# LiDAR Quality Assessment Report

ARRA-MI\_LowerPeninsula\_2010

LiDAR Data Acquisition covering the Iosco, Arenac, and Bay Counties, MI

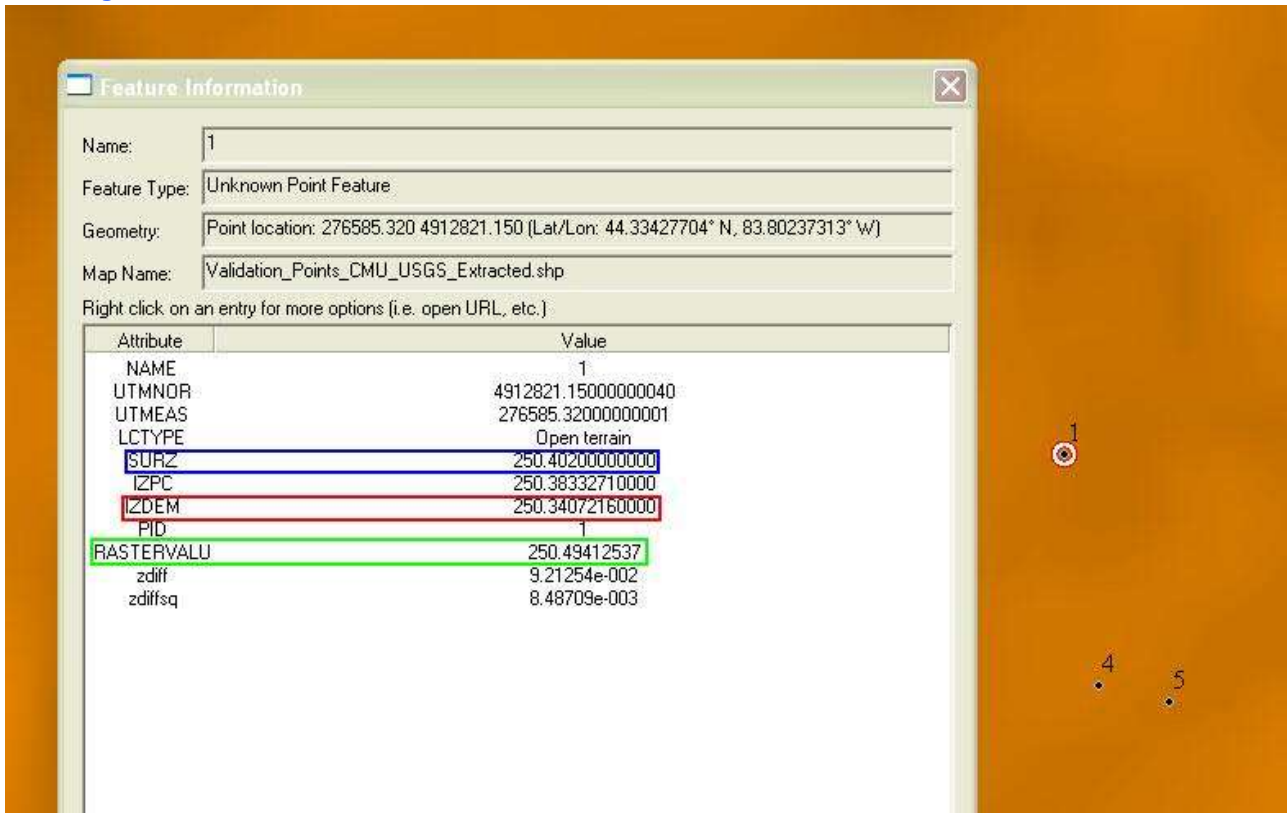
Technical section of proposal documented stated 2-m horizontal resolution DEM's would be prepared, DEM's received are 3m. Acceptable as is.

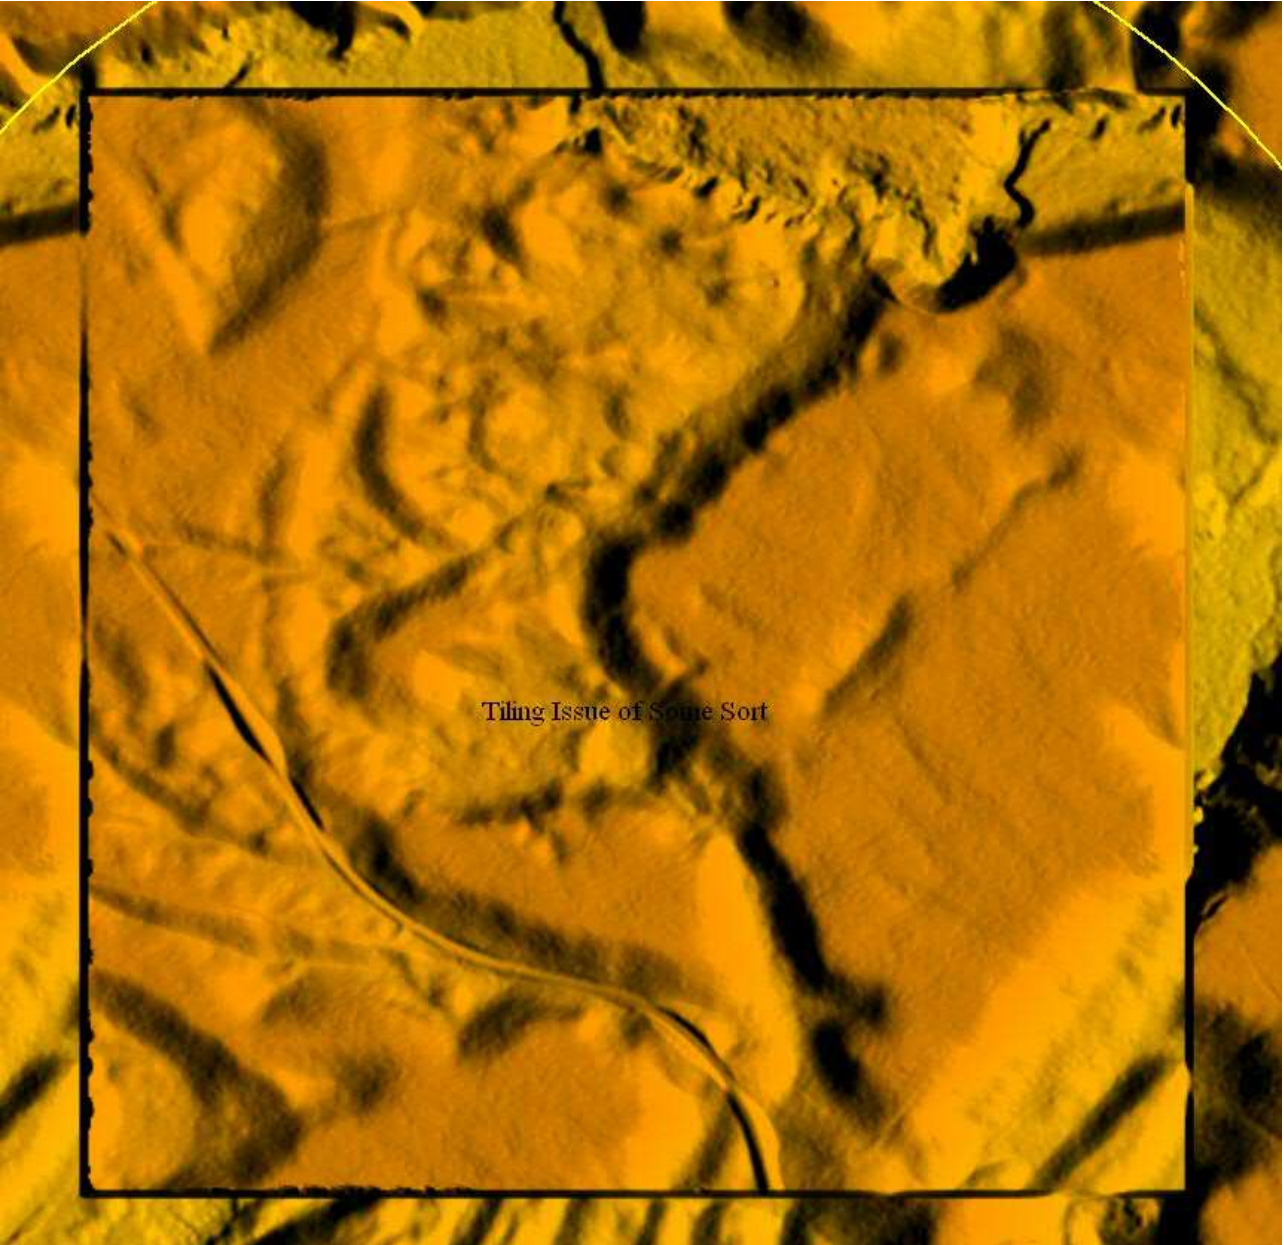
::::::::::FIXED IN RE-DELIVERY::::::::::The FVA is higher than the acceptable value for v13 when tested at the USGS using the CMU Validation points. Further investigation reveals that the CMU reported DEM values at validation point locations are incorrect. See screen capture: in this example validation point 1 was surveyed as having an elevation of SURZ=250.4020000000, and CMU reported a raster value for this point of IZDEM=250.3407216000, but NGTOC has found that raster value at this point's location is RASTERVALU=250.49412537, this issue occurs with other points as well. \*\*see Redeliver Vertical Accuracy Note

Tiling Issue of Some Sort

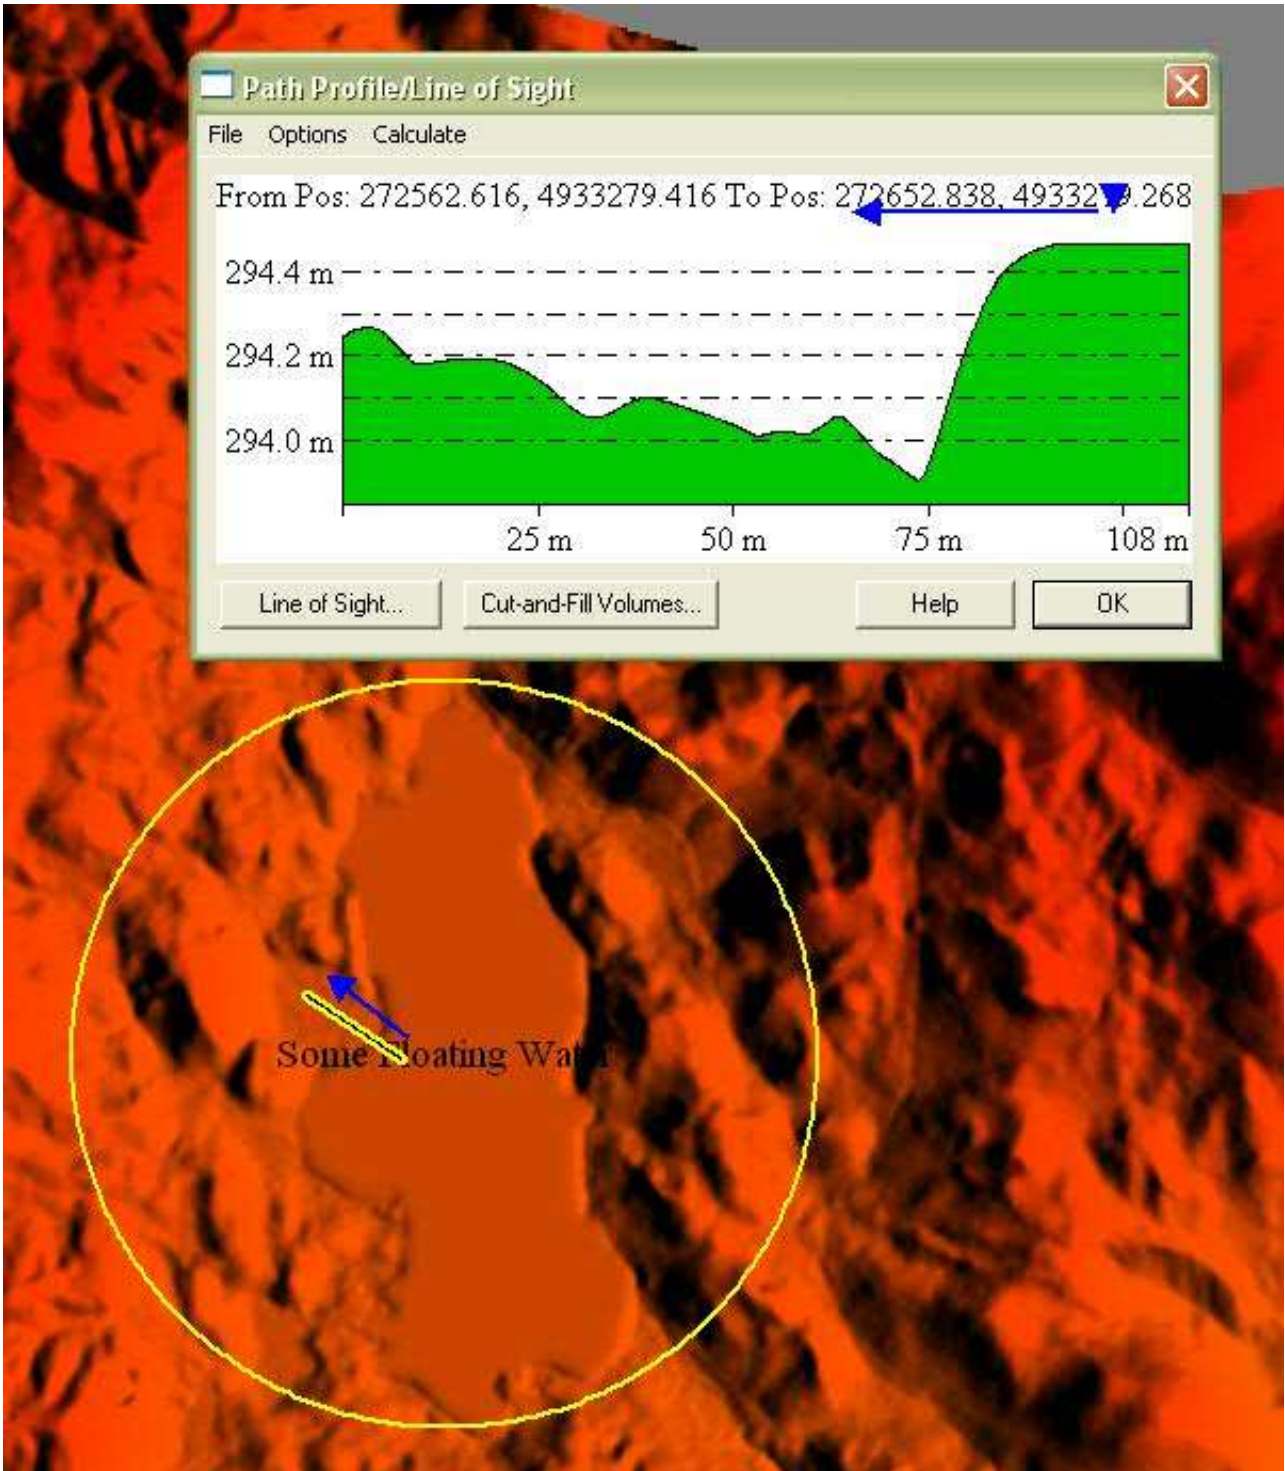
::::::::::FIXED IN RE-DELIVERY::::::::::A Major Concern of these DEM's are that at least 2 DEM's appear to be missing. Tile 345 is identical to 344 and 1894 is identical to 1893. Also 635 appears to be a random tile. I have verified that the necessary data to grid these areas is available in the point cloud.

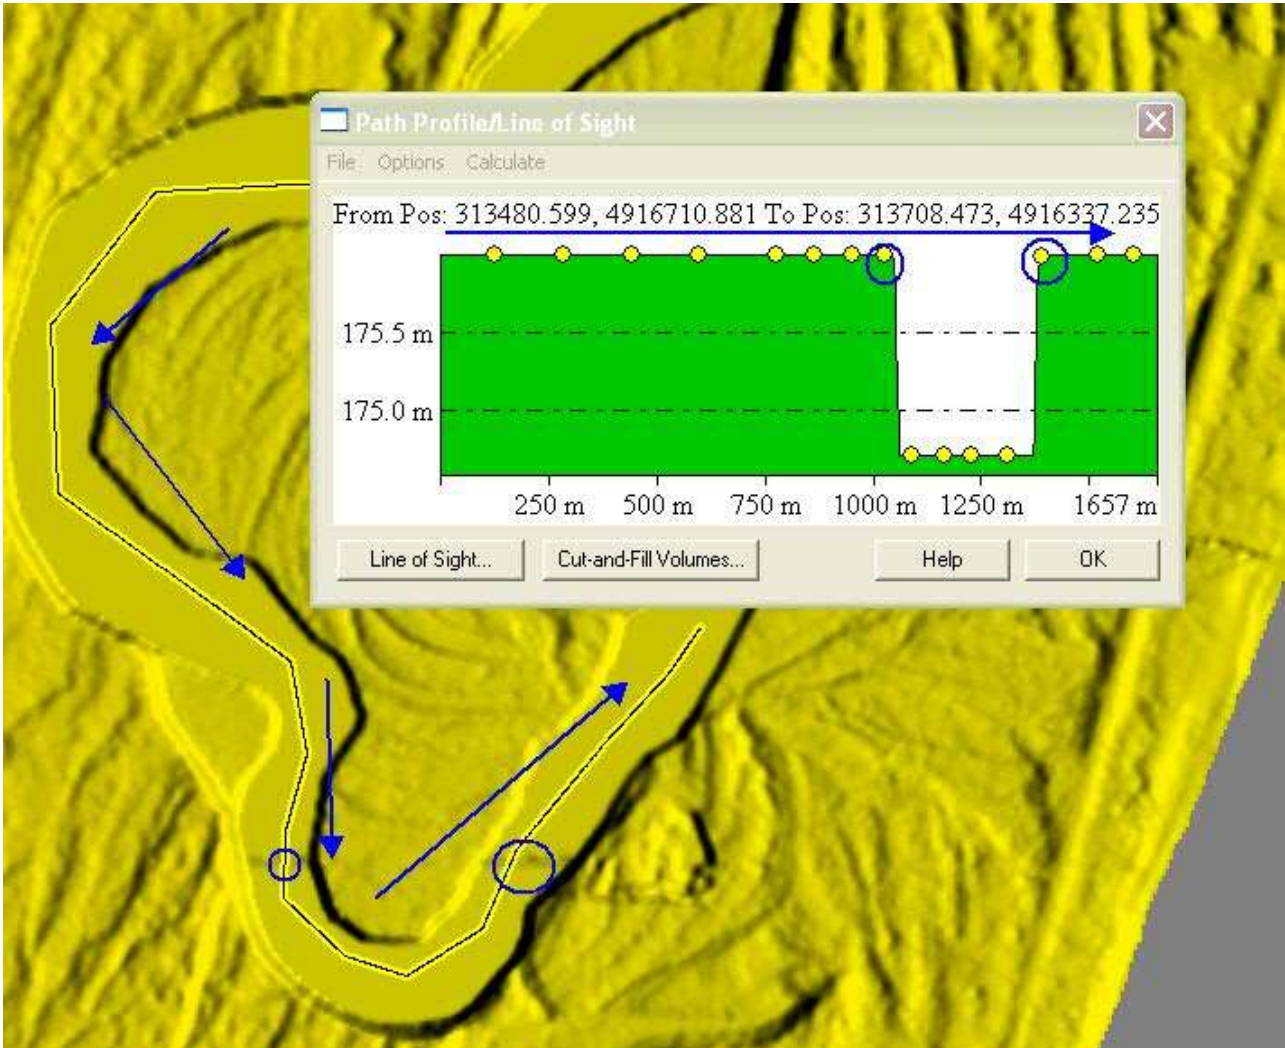
.....FIXED IN RE-DELIVERY.....There were a couple issues with water bodies: 2 Instances of mild floating water where the waterbody could be set lower.

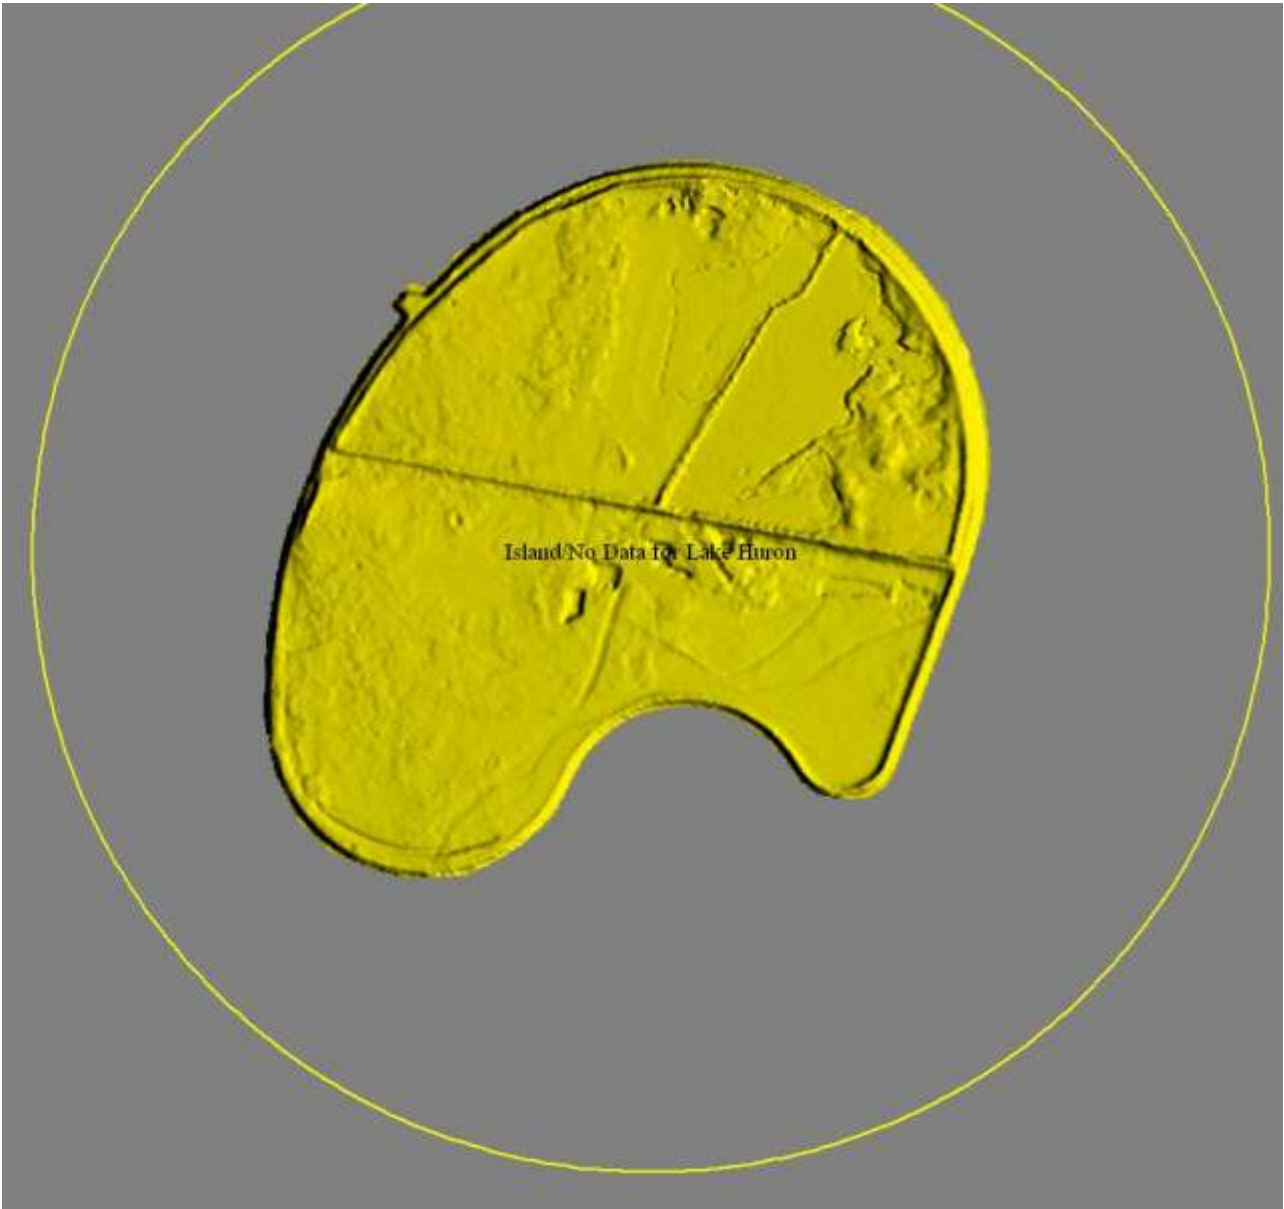
::::::::::FIXED IN RE-DELIVERY::::::::::One Raster Data Void was located and marked in the DEM\_Error\_Tags Shapefile.

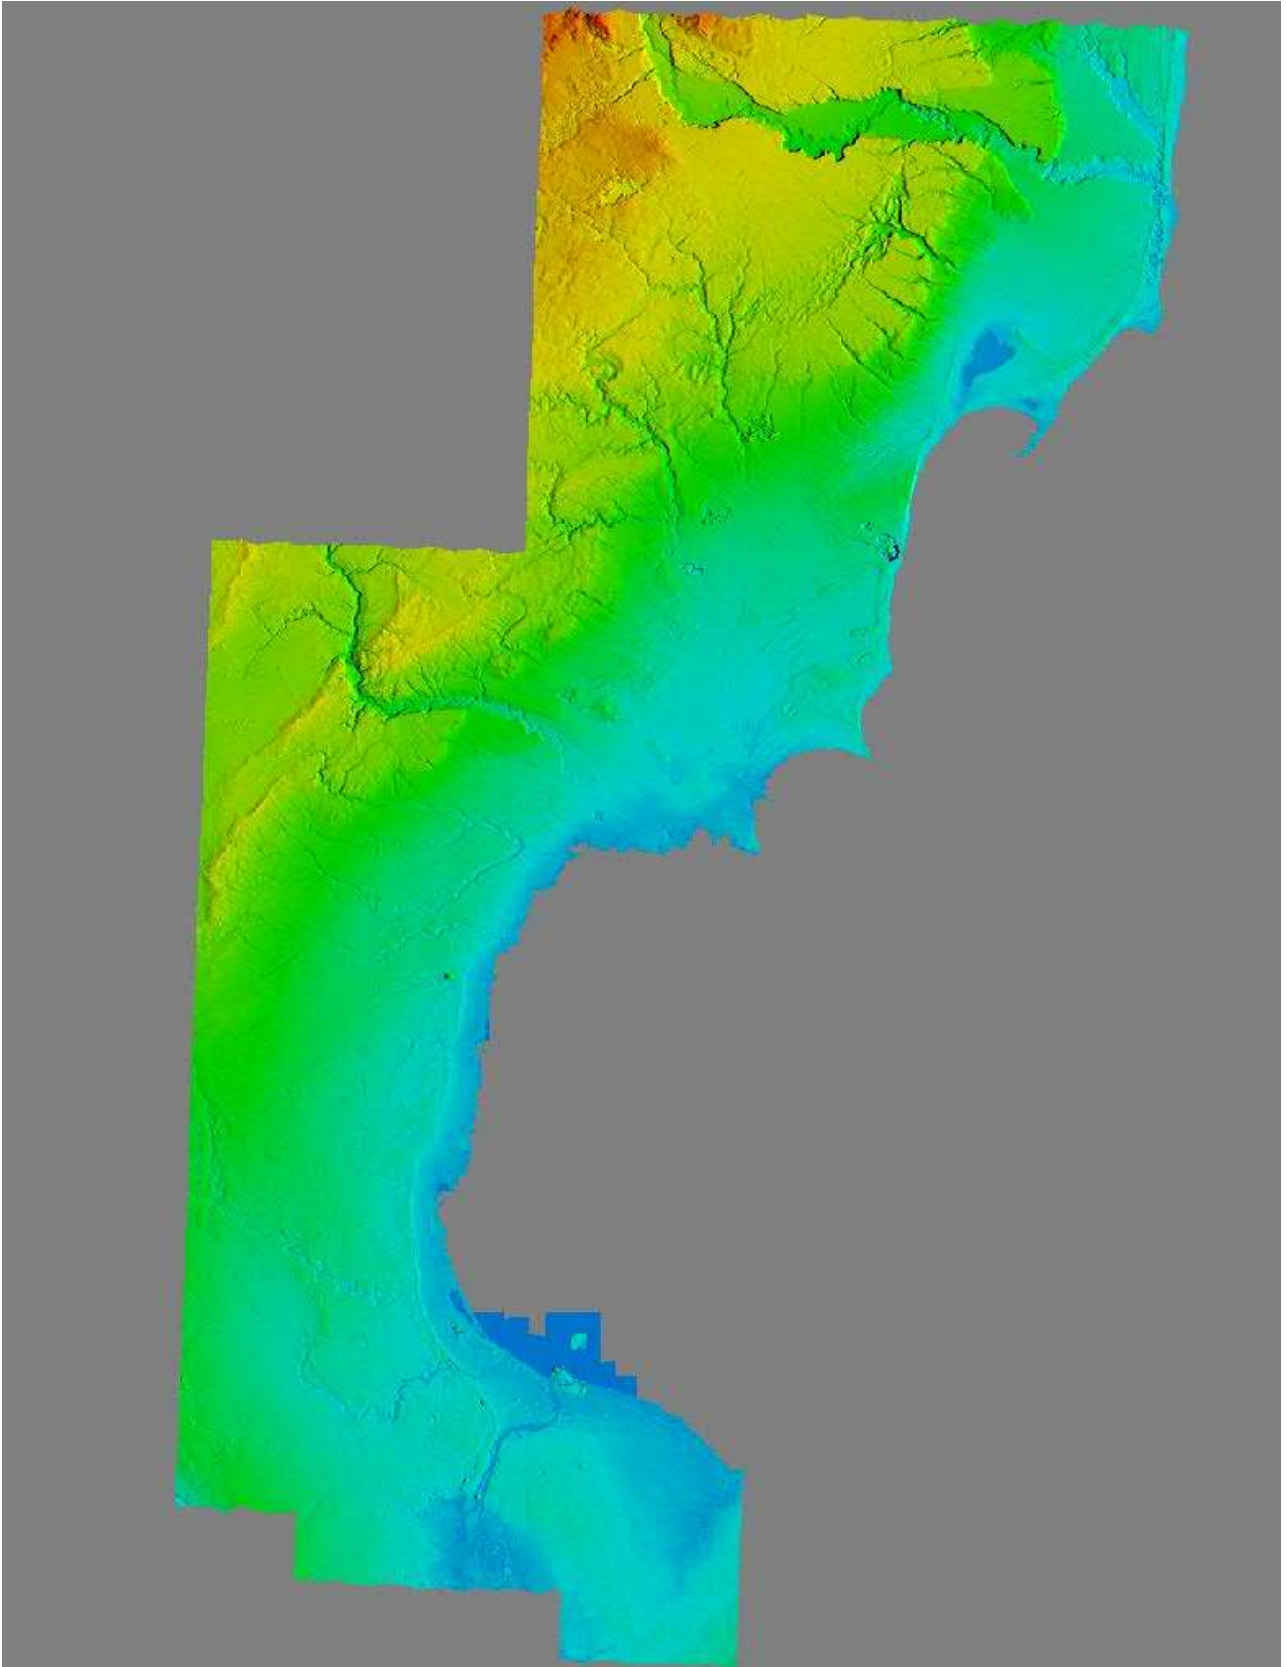
::::::::::FIXED IN RE-DELIVERY::::::::::(Lake Huron included around the area with the island) Finally, the issue of including an elevation for lake Huron needs to be addressed, especially in the context of the island located just of the coast.
